**CLOSURE PLAN - ADDENDUM NO. 2**

**Martin Lake Steam Electric Station – PDP-5  
Rusk County, Texas**

February 2024

**Closure Plan, PDP-5, Figure 4**

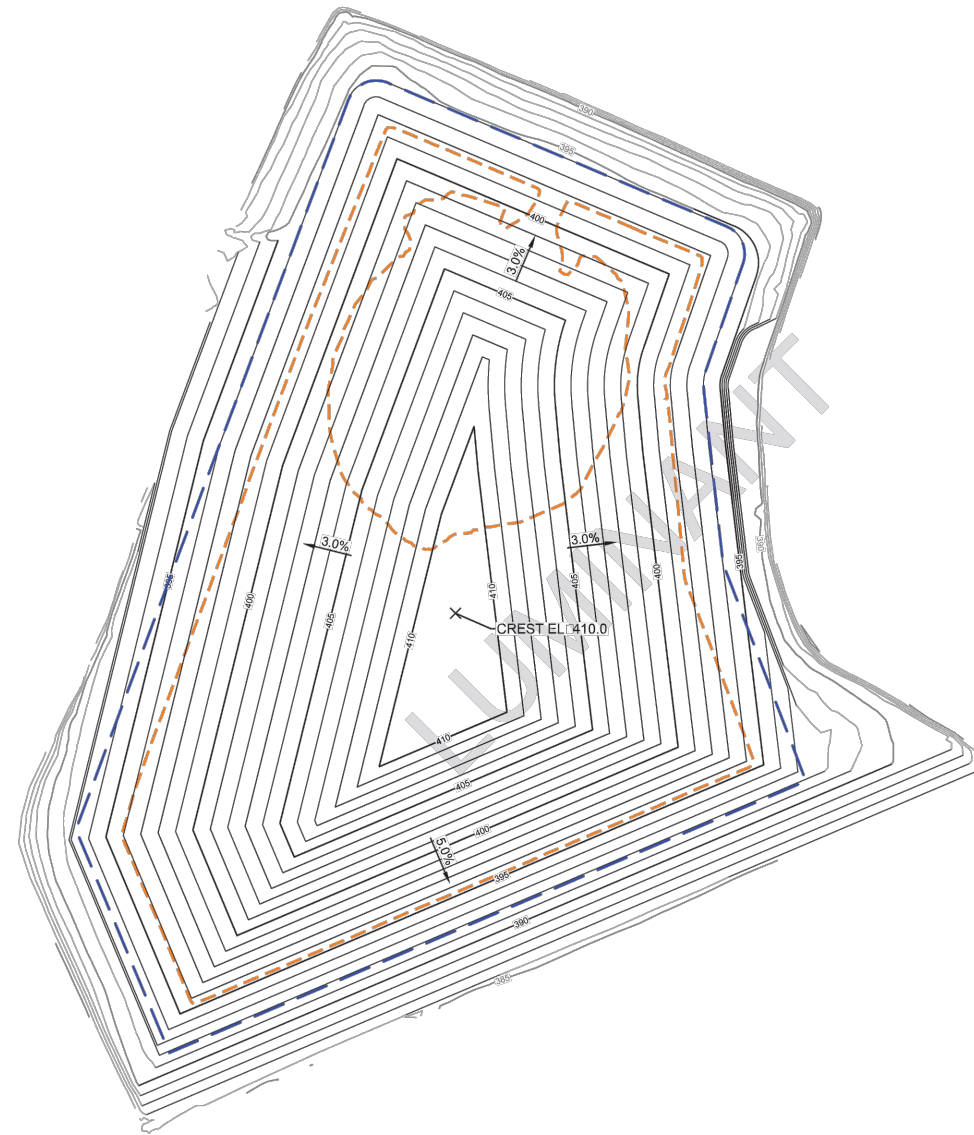
PDP-5 Figure 4 was revised with the signature and seal of a Texas Licensed P.E. and dated accordingly. Additionally, a statement was added to the drawing stating that final elevations for the CCR unit would be provided during closure. The revised drawing can be found in Appendix A of this Addendum.

FINAL ELEVATIONS FOR THE UNIT  
 WILL BE PROVIDED AT CLOSURE.
